Planning Commission Application

FORT GRATIOT PLANNING COMMISSION SITE PLAN REPORT

RE: Smart Storage Solutions - Mini Storage Site Plan, 3134 Keewahdin Road, Fort Gratiot Township (Plan Review No. 01)

SITE PLAN
SMART STORAGE SOLUTIONS
3134 KEEWAHDIN ROAD, FORT GRATIOT, MI 48059

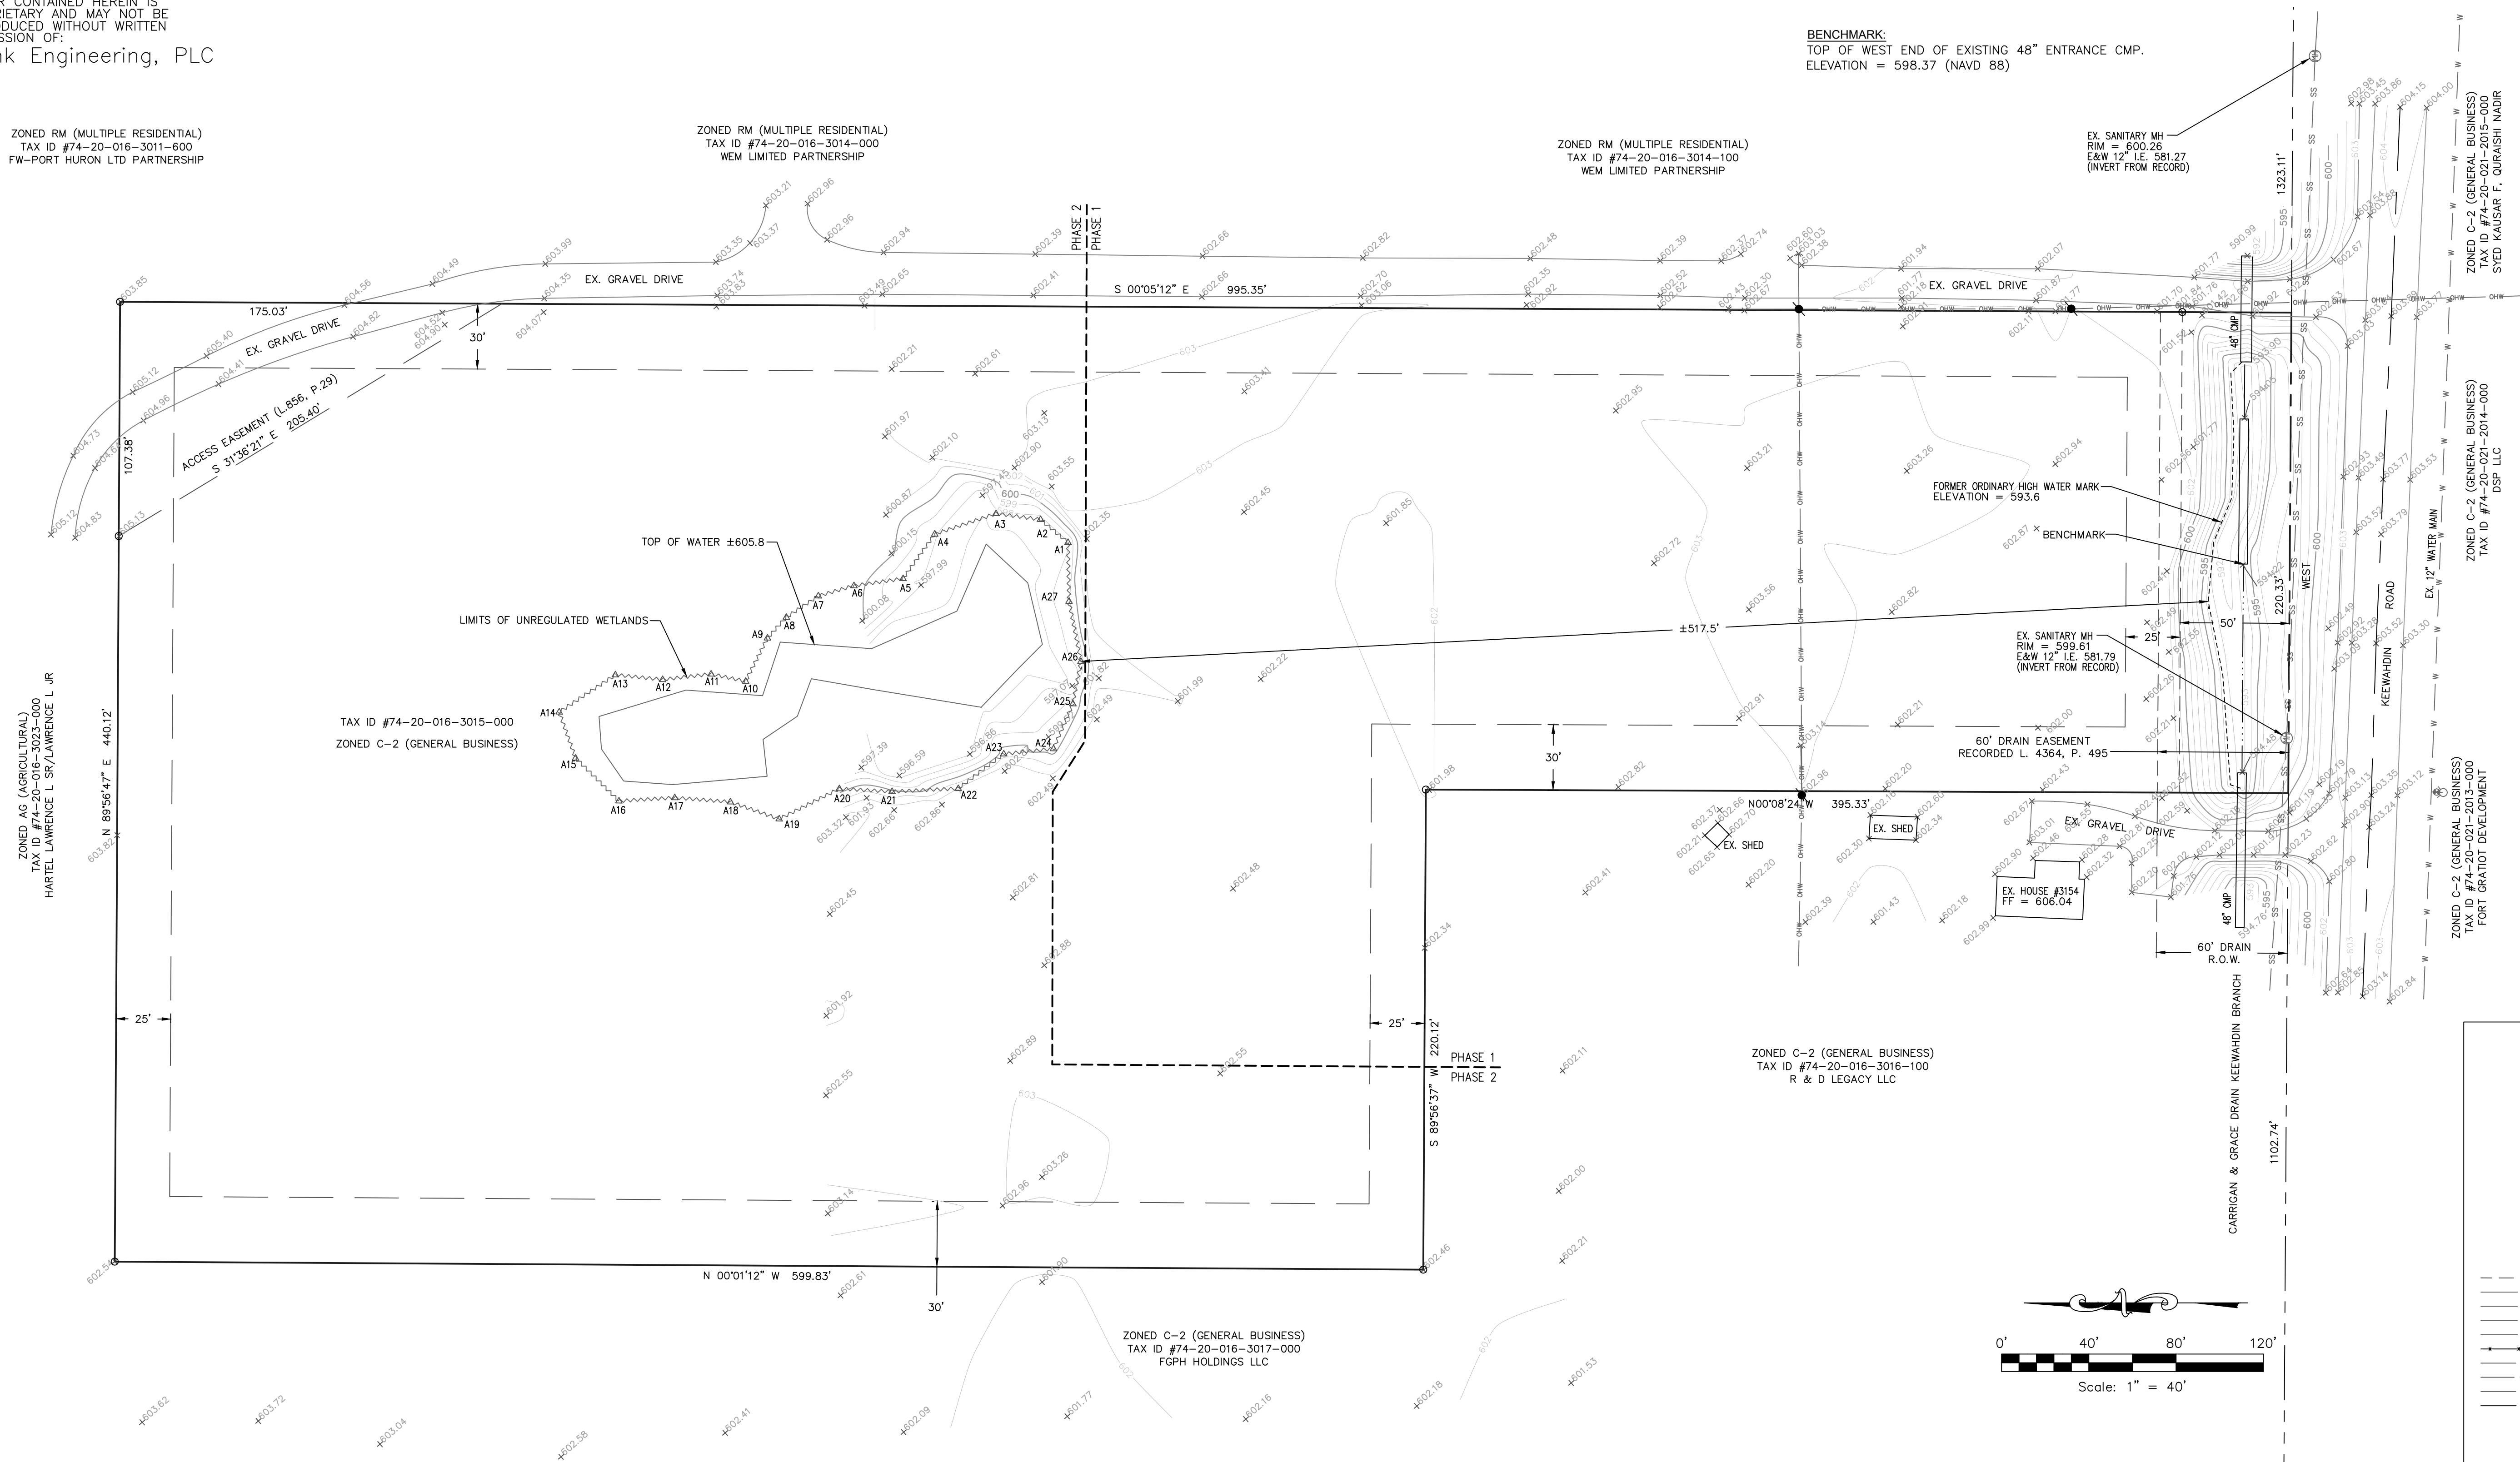
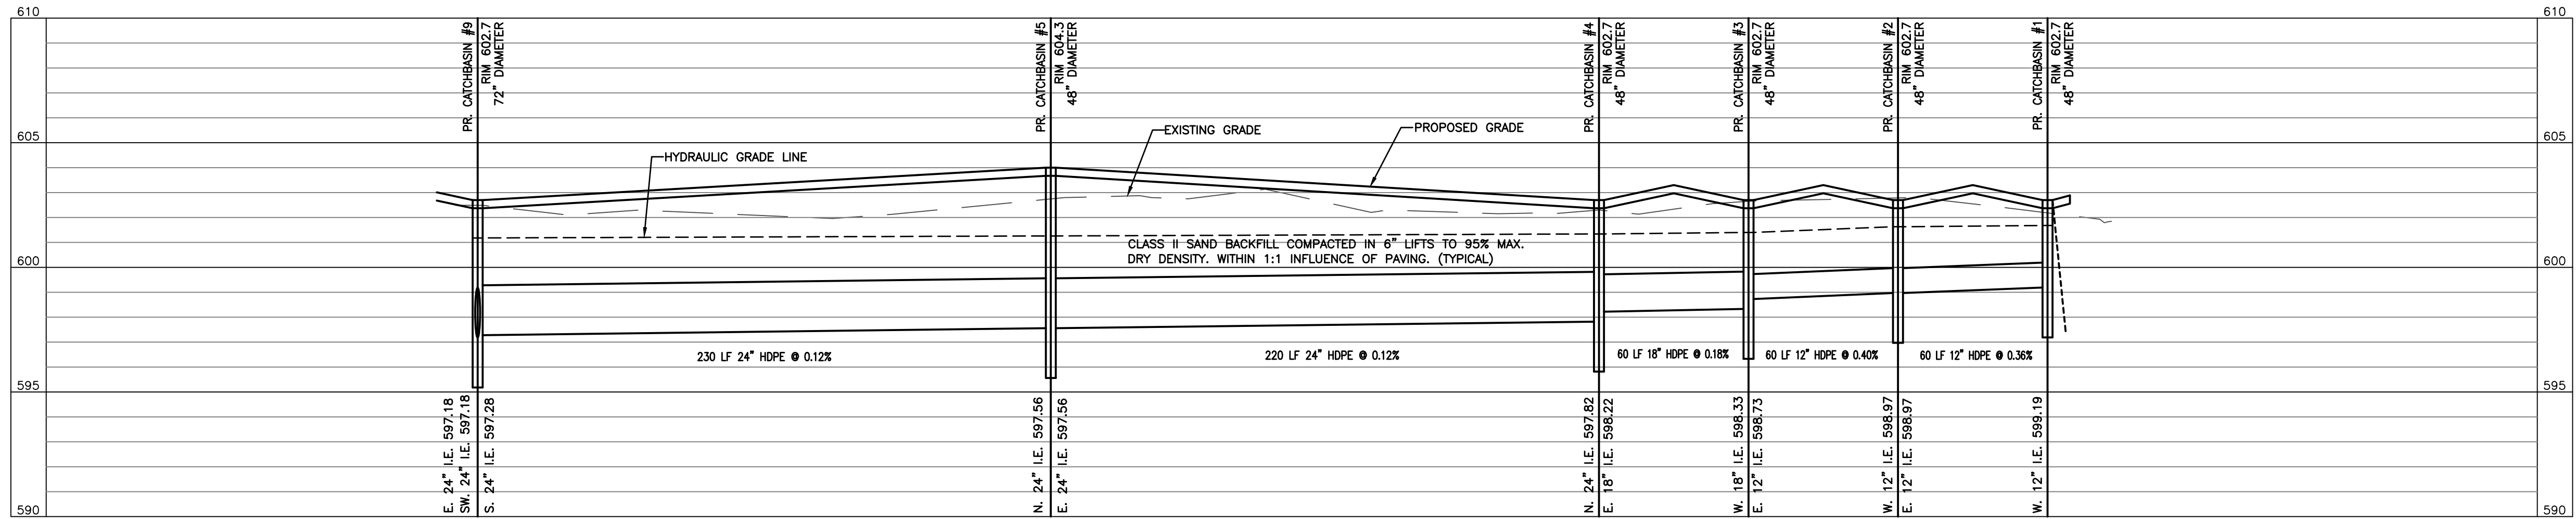
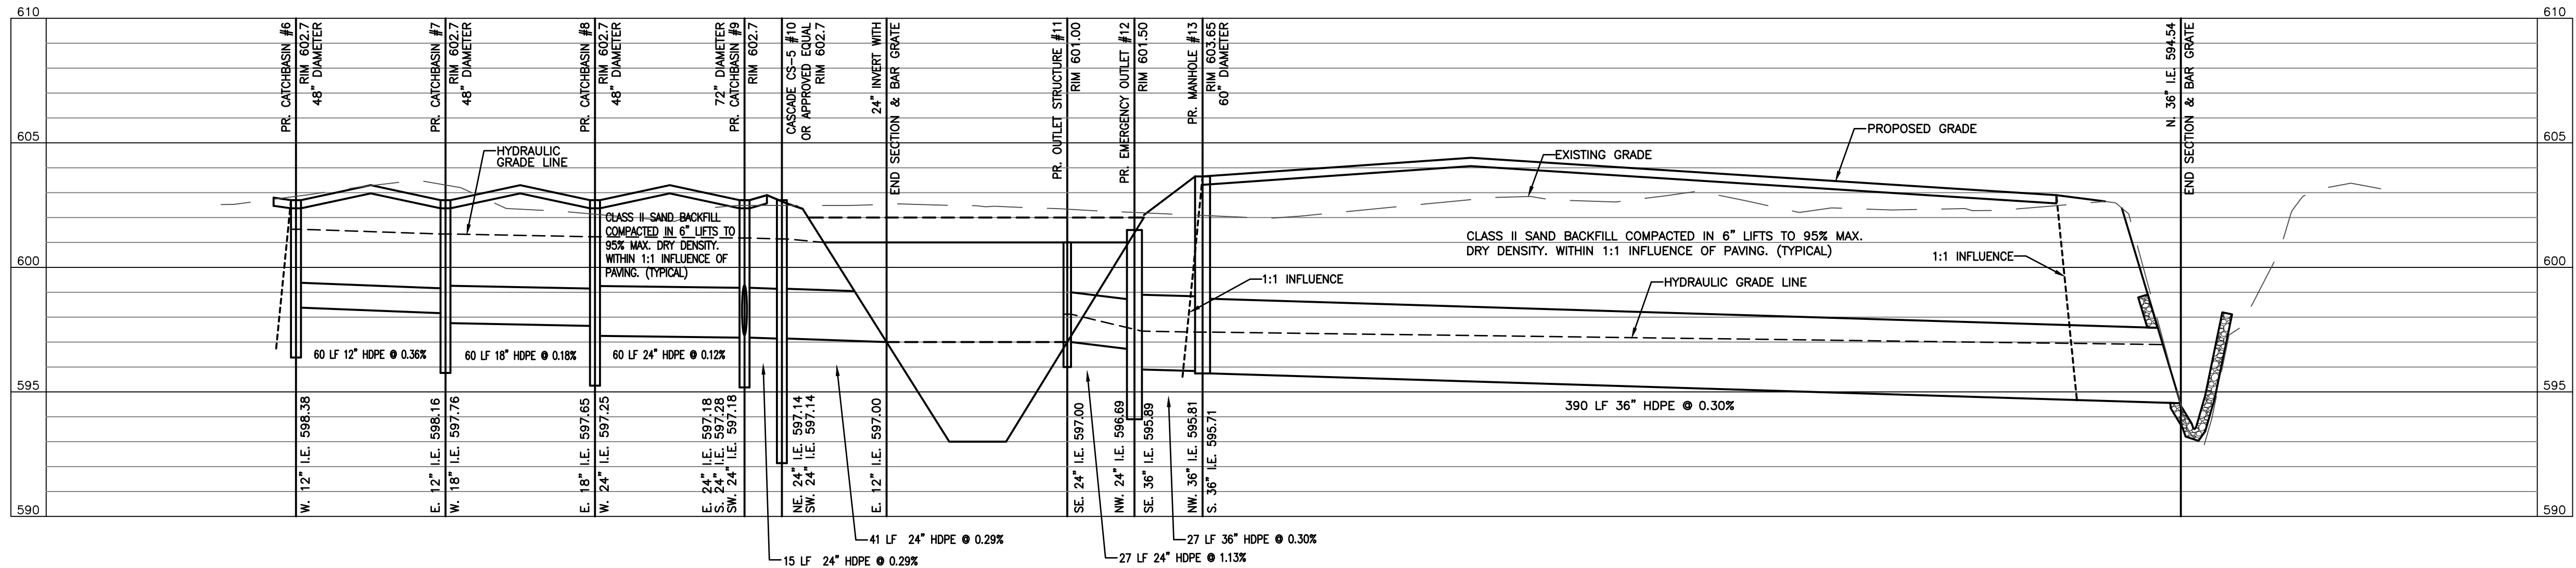
2. A 6-foot-high decorative screening wall is proposed around the east, south and west sides of the site. The wall is shown on the neighboring properties on the east and west sides of the site and within the drain easement on the south side of the site. The wall on the east and west sides of the site may have been shown in this manner to prevent drawing linework overlapping. If this is the case, a note should be added to the drawings specifying that the wall be placed on the property line or as otherwise intended. We recommend that the wall on the south side of the site be relocated out of the county drain easement.

3. The 6-foot-high decorative screening wall around the property appears to be also functioning as a retaining wall based on the proposed 2 feet of differential between finish site grades and existing grades as provided on Sheet 3 and as shown in the masonry wall detail drawing on Sheet 5. Calculations should be provided demonstrating the ability of the wall to support the loading conditions expected.

4. Lineal footage of the 6-foot-high decorative screening wall listed on Sheet 3 of the plans appears incorrect. This should be reviewed and corrected accordingly.

1. The plans indicate that shielded wall mounted lighting is to be provided (see Sheet 3). No fixture data has been provided. Details of fixture model type should be added to the drawings.
2. We recommend that a site photometric plan be provided to verify with compliance of Section 38-611(5) of the Township Zoning Ordinance.
